SAFETY RECALL CODE 0812 - 1999 X1 REAR BRAKE LINE AND POSITIVE BATTERY CABLE

B-020

Figure 1. Rear Brake Line - Right Side

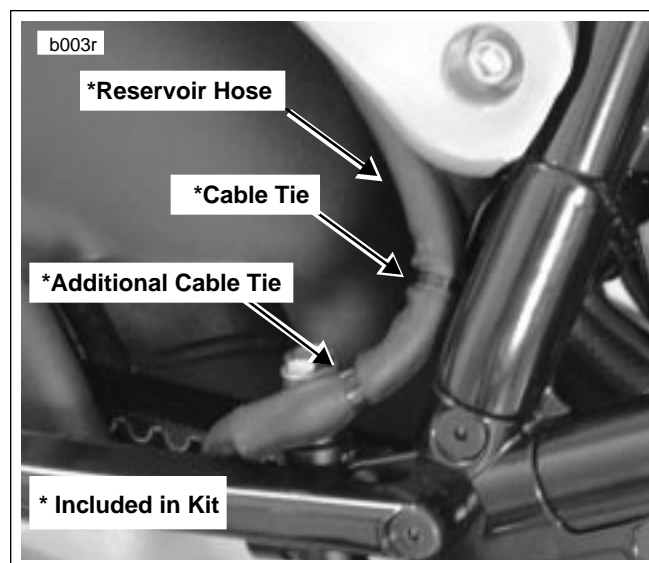
7. See Figure 1. Cut cable tie holding rear brake reservoir hose to rear brake line above rear master cylinder on right side of motorcycle.
8. See Figure 4. Disconnect two wires from rear brake light switch.
9. Remove rear master cylinder banjo bolt and two banjo washers. Discard banjo washers.
10. Remove rear brake caliper banjo bolt and two banjo washers. Discard banjo washers.
11. Carefully push up on bottom of oil tank to allow rear brake line tangs to be freed from studs on the bottom of the oil tank.
12. See Figure 2. Cut cable tie on wiring harness and cable tie on vent tube on left side of bike.
13. Slide rear brake line into area where battery usually sits and then off of bike through left side of frame.
14. See Figure 4. Remove rear brake light switch from original brake line.

22. See Figure 1. Inspect rear brake reservoir hose on right side of motorcycle for damage. Replace as required by installing **new** replacement hose provided in kit. If hose is undamaged, proceed to step 23.

23. See Figure 1. Install two cable ties (thick) to reservoir hose and rear brake line in **two** locations as shown in figure. Use care to avoid pinching hose.

Figure 2. Rear Brake Line - Left Side

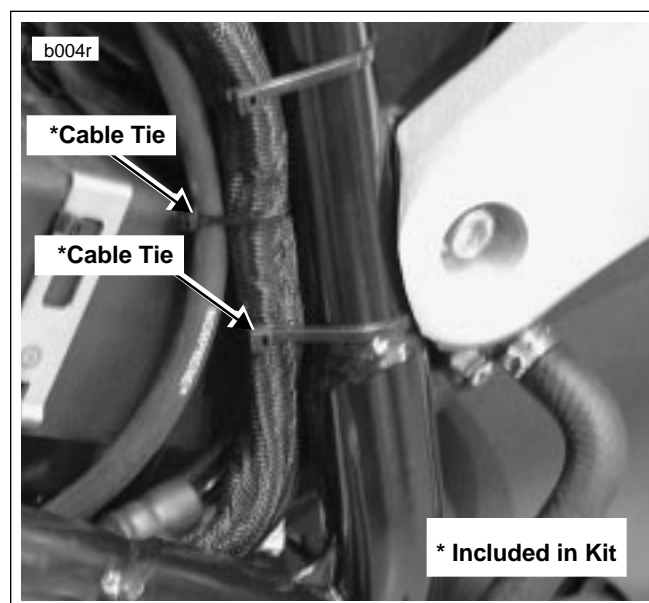
25. See Figure 6. Inspect positive battery cable and vent lines (transmission vent and cam cover vent) for damage. Replace as required.
26. See Figure 2. Cable tie vent hose and wire harness to frame on left side of motorcycle. NOTE: Use thick cable tie on wire harness and thin cable tie on vent hose. Use care to avoid pinching hose.

Figure 3. Loop Clamp Orientation Before Installation

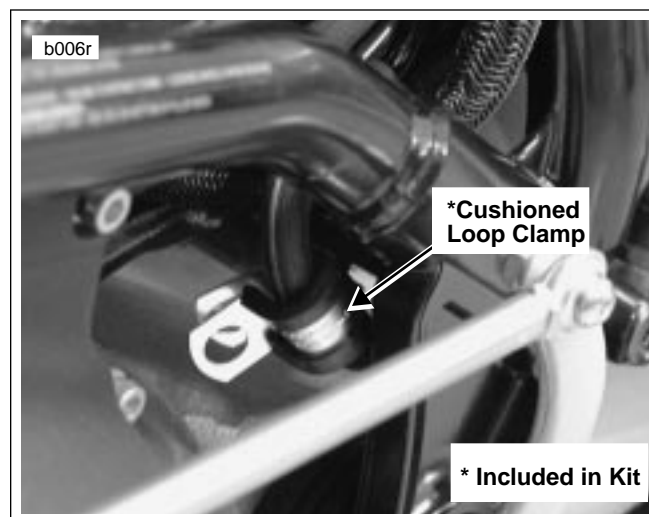
19. See Figure 3. Install loop cushioned clamp provided in kit to brake line and then to bolt side of tie bar fasteners. Loop clamp is oriented down and to the left. Install tie bar to frame with bolt, washer and loop cushioned clamp on lower side of tie bar and **new** locknut on upper side of tie bar. Tighten to 30-33 ft-lbs (40.7-44.7 Nm).

Figure 4. Rear Brake Light Switch

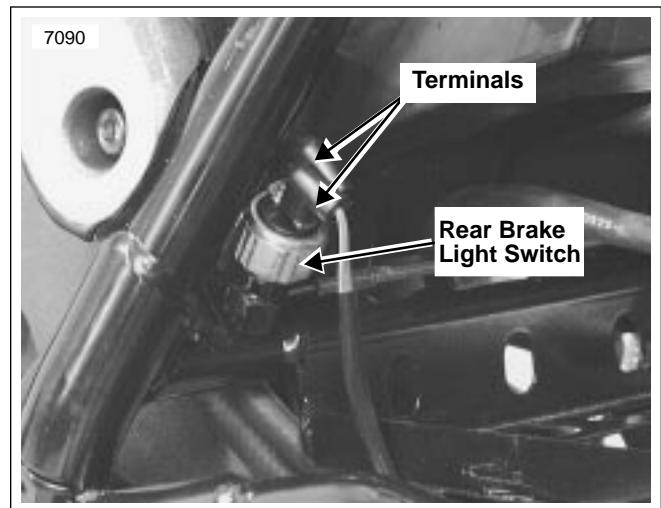
15. Coat threads of rear brake lamp switch with LOCTITE PIPE SEALANT WITH TEFLON and install to **new** brake line. Tighten switch to 84-96 **in-lbs** (9.5-10.8 Nm). Tighten as required to orient terminals perpendicular to brake line.

34. Attach oxygen sensor connector to battery strap with **new** thin cable tie on left hand side of motorcycle.
35. See Figure 4. Connect rear brake light switch wires to rear brake light switch.

Figure 5. Rear Brake Line Routing

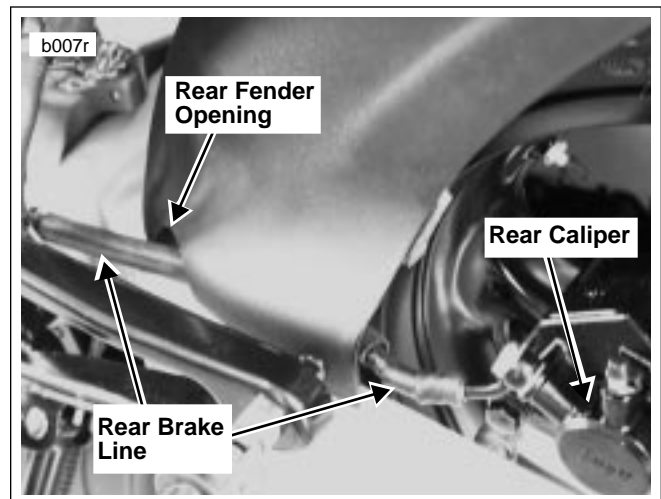
17. See Figure 5. Working from the right side, install **new** brake line and align metal portion of brake line with rear master cylinder. Route caliper side of brake line in front of tie bar and through rear fender opening to rear caliper.

Figure 6. Positive Battery Cable Routing

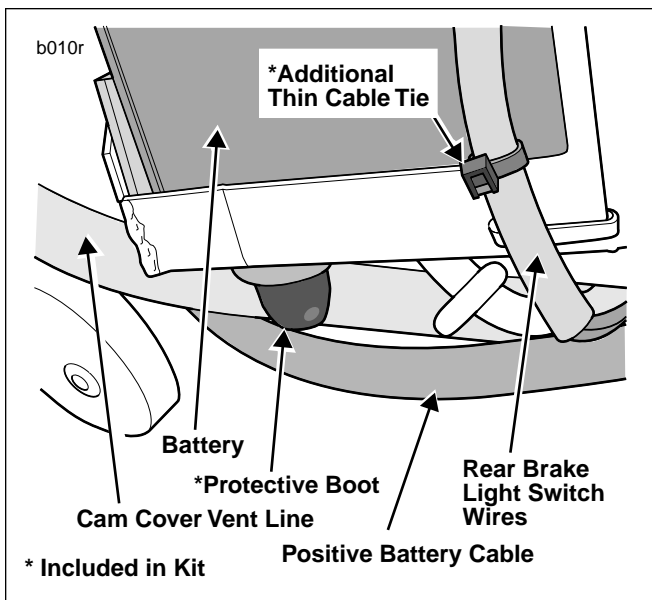
27. Cut cable tie on frame cross member behind battery tray that secures cam cover vent and transmission vent.
28. See Figure 6. Attach cam cover vent (thinner of two vent lines) to frame cross member in original location with **new** (thick) cable tie. Make sure cam cover vent line is routed inboard of stud and nut on bottom of battery tray.

30. See Figure 7. Attach transmission vent line to oil return line as shown with **new** (thick) cable tie.
31. See Figure 6. Reroute positive battery cable from starter solenoid post **under** rear brake light switch wires and **under** cam cover vent line then behind and over battery to positive terminal.

32. See Figure 6. Install protective boot, included in kit, over stud and nut on bottom of battery tray on right hand side of motorcycle.
33. Install battery with strap and nut. Tighten nut to 40 in-lbs (4.5 Nm).

36. See Figure 6. Attach rear brake light switch wires to battery strap with **new** thin cable tie on right hand side of motorcycle. NOTE: HDI (all except Canada, Japan and New Zealand) models do not require this cable tie as the brake light switch wire routing is different.

Figure 7. Transmission Vent Line Routing (Rear View)

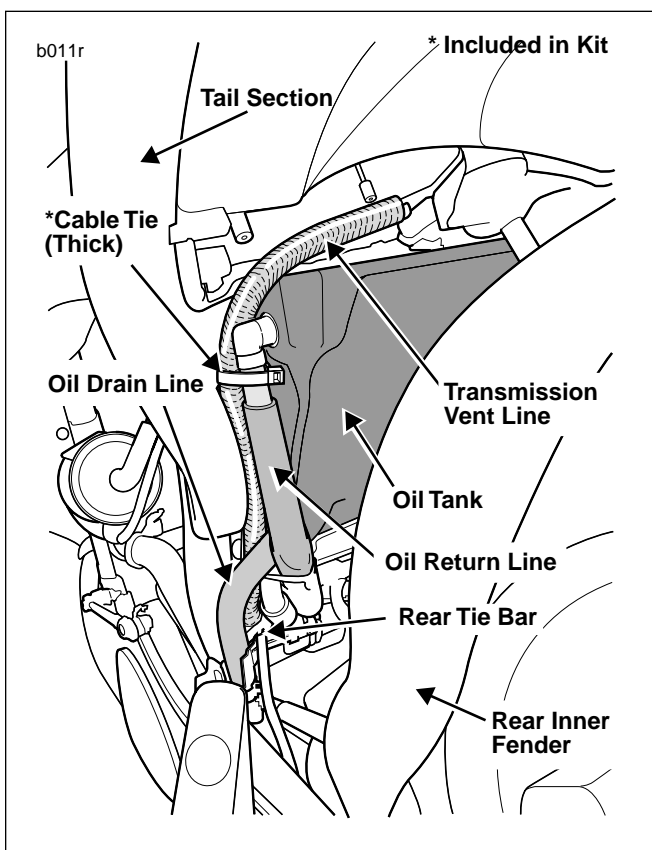
29. See Figure 7. Reroute transmission vent line to **left** side of motorcycle, **under** battery tray, **over** rear tie bar, **above** rear brake line, **between** oil drain line and tail section, **above** oil return fitting (on oil tank), and **over** the top of the oil tank. Use care to avoid kinking hose after tie bar.
